Technical News Bulletin

Steinhausen, October 2020

FlexIS Controller Replacement

The new controllers JC-647B (with new SB-I-B and INT-B) require following FlexIS Software Version (Update Package Version)

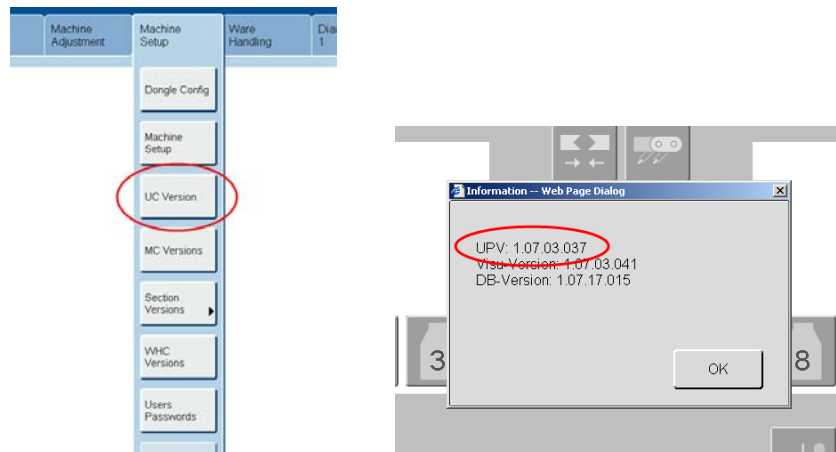
The new controllers JC-647B with the submodules SB-I-B and INT-B require a new FlexIS software version.

FlexIS 1 (with UC 1): 2.07.00.000 or higher (released May 2020)

FlexIS 2 (with UC 2): 2.03-release-1024 or higher (released May 2020)
